The following are responses from Snake River Oil and Gas (SROG) to EPA's 10/29/2020 follow-up questions regarding SROG's 8/21/2020 response and EPA 6/10/2020 comment letter. The actual text of the EPA 10/29/2020 questions are shown in blue font, followed by SROG's response in red. Attached for reference as Attachment A is the 20201029 EPA Response to SROG.

SROG Responses to EPA Questions 1&2 of October 29, 2020

Proposed Injection Well: 1. Lower Confining Zone  
2. Depth to Injection Interval

STRATIGRAPHIC CROSS-SECTION  
ML #1-11 & DJS #2-14 Wells  
DATUM: Sand 3 top  
Section shows deeper stratigraphy

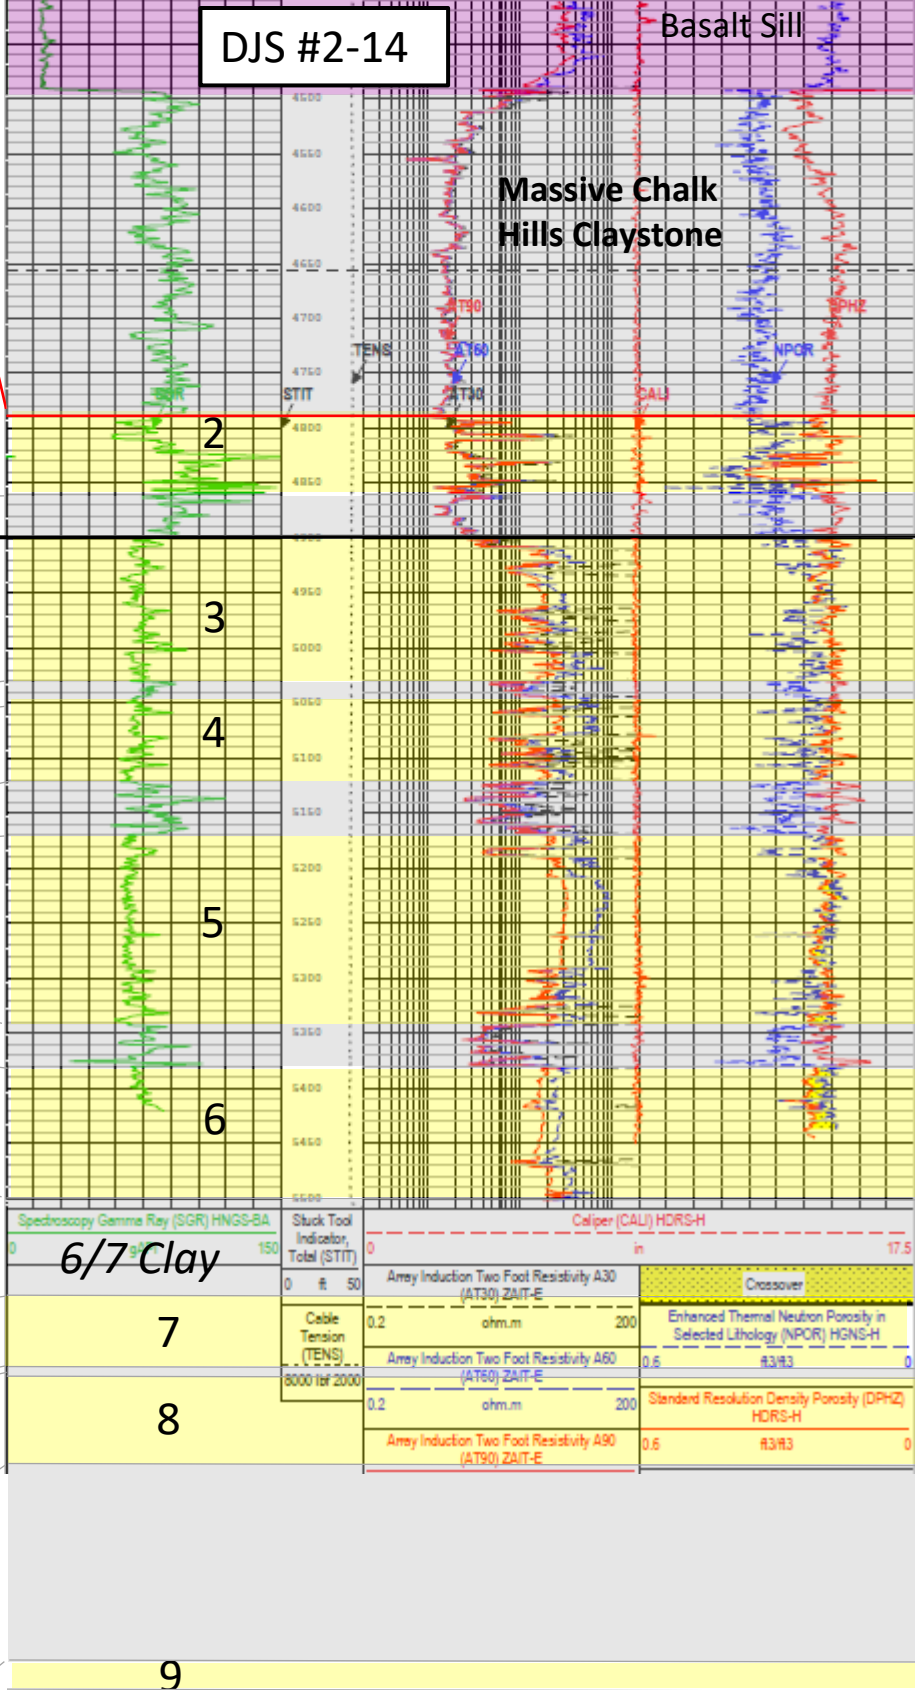
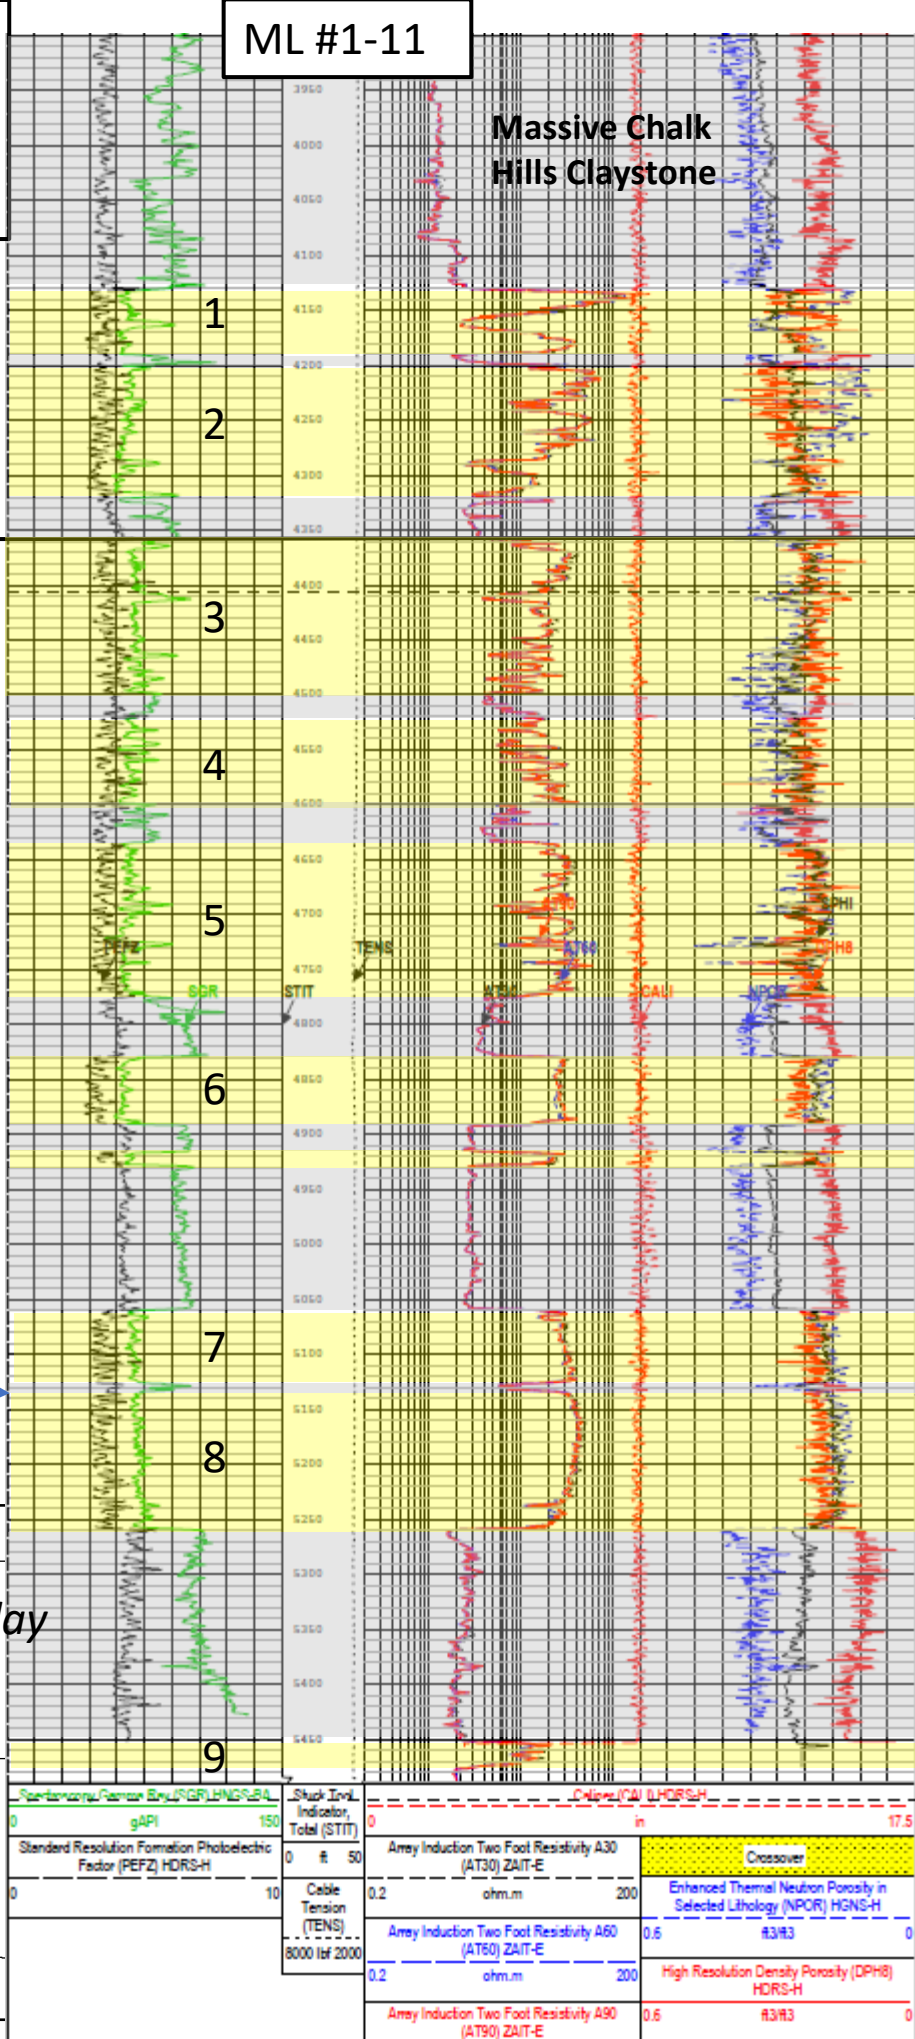
1. Based on the regional faulting and stratigraphic dip across the Western Snake River Plain, it seems improbable that specific claystones seen in the Ore Ida well correlate with the lower confining zones below the bottom of the DJS 2-14 wellbore. Nearby wellbores, including ML 1-11, provide evidence of claystones between Willow Sands, but local unconformities may exist across faults. Please identify a lower claystone seal existing below the proposed injection zone that is competent and continuous across Fault Block E. Also, please indicate the depth of this lower confining zone as it occurs across the field. (This information will be needed for the next question, too).

*Attachment D, Slide 6* is the same stratigraphic cross-section as slide 5, but here the deeper stratigraphy below TD of the well is shown as inferred from the neighboring wells. Again, the 6/7 Claystone is found in all wells in the Willow Field area drilled deep enough to penetrate the interval. This is established by wells surrounding the DJS 2-14 to the north, west, south and east as will be shown on subsequent cross sections.
